Norwalk Planning & Zoning Commission
125 East Avenue
Norwalk, Connecticut

MEMORANDUM

TO: Planning & Zoning Commission - Louis Schulman, Chairman
FROM: Bryan Baker, Principal Planner
RE: [#2022-31 R/SP/CAM – BPC Capital Management I, LLC – 3 Park Street – Building zone regulation text amendment to Article 50 to reduce the minimum lot size for historic preservation developments in conjunction with a proposed 11-unit historic preservation development](#)

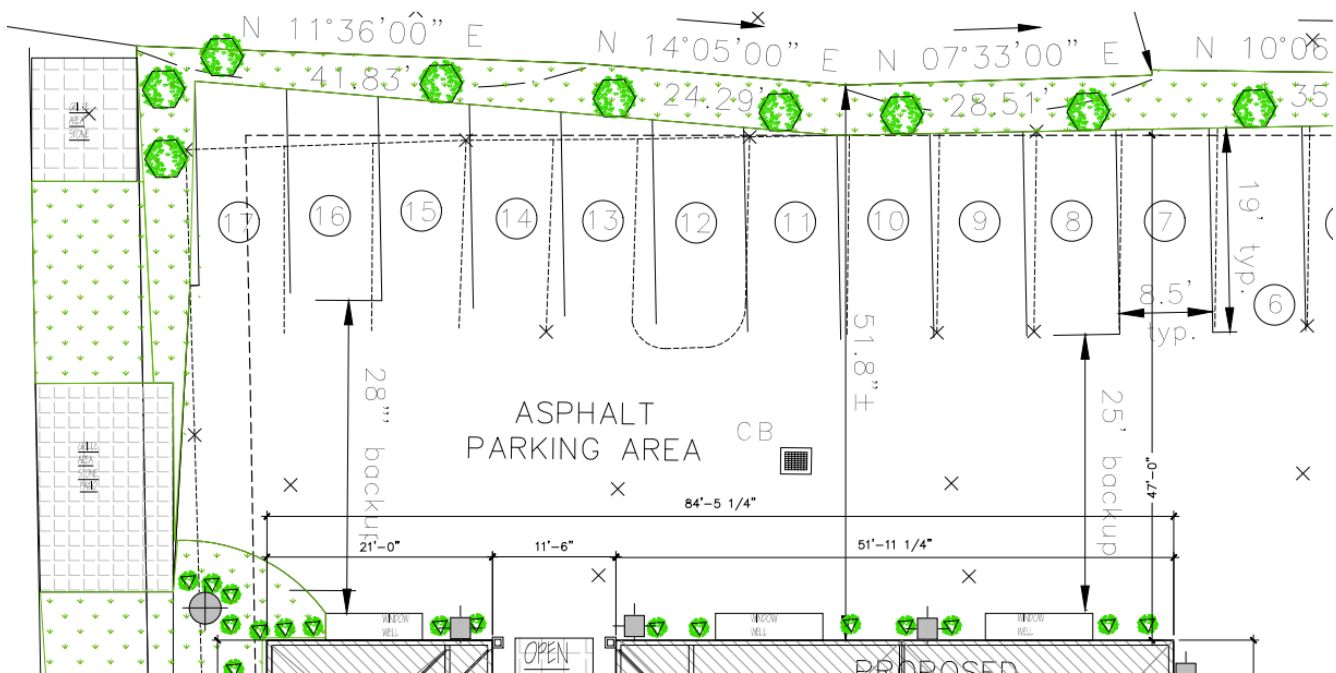
2. Revisions to the site plan.
- a. The existing site plan shows that the overhead electrical wires that exist today are proposed to remain. Staff recommends that these wires be buried underground which would add to the visual appearance of the area as well as hazard mitigation during storms. Similarly, as part of the 3 East Wall Street project, the overhead wires were buried underground.

- b. The existing site plan also shows that the existing asphalt sidewalk is to remain. Staff recommends that the sidewalk be replaced to meet the current City of Norwalk standards and any other recommendations/requirements provided by DPW and TMP. In keeping with this, the existing walkway from the sidewalk to the front entrance of the historic building is also asphalt, Staff recommends that the asphalt be replaced with a more architecturally appealing material such as brick, stone or stamped concrete.

c. At the rear of the property, it appears that there is excess backup space being provide for the parking spaces, ranging from 25' of backup space to 28' of backup space. Staff recommends that the parking spaces be moved as close to the buildings as possible, lowering the backup space to the 24' minimum requirement which would allow the applicant to add more landscaping and buffer area along the rear property line. In doing so, this would reduce the overall amount of impervious surface on the lot which as proposed is currently at the 70% maximum allowed.

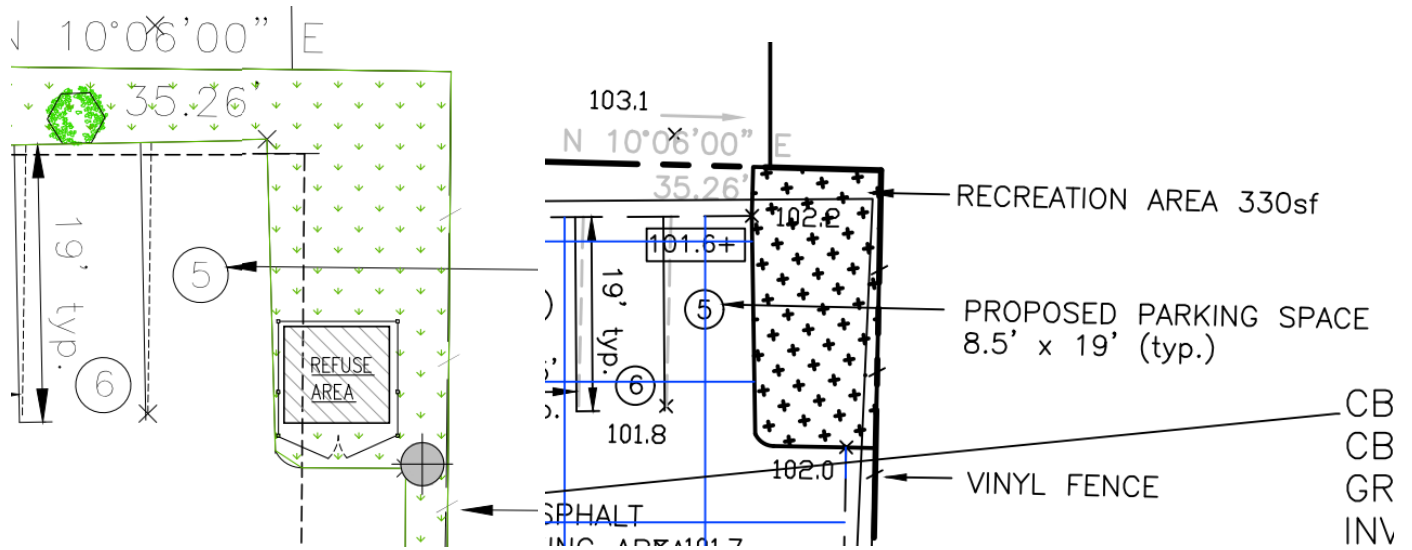
- d. Details should be provided on whether the three stone patios that are located along the southern property line area pervious or not. If these patios are impervious, despite the Building Zone Regulations not necessarily counting patios towards coverage calculations, the property would likely exceed the 70% maximum threshold for coverage.
- e. The recreation area in the northwest corner of the lot, adjacent to the parking area, is also shown to be the location of the dumpster. Staff recommends that the dumpster be moved to a different location on the site so as not to interfere with the recreation area.
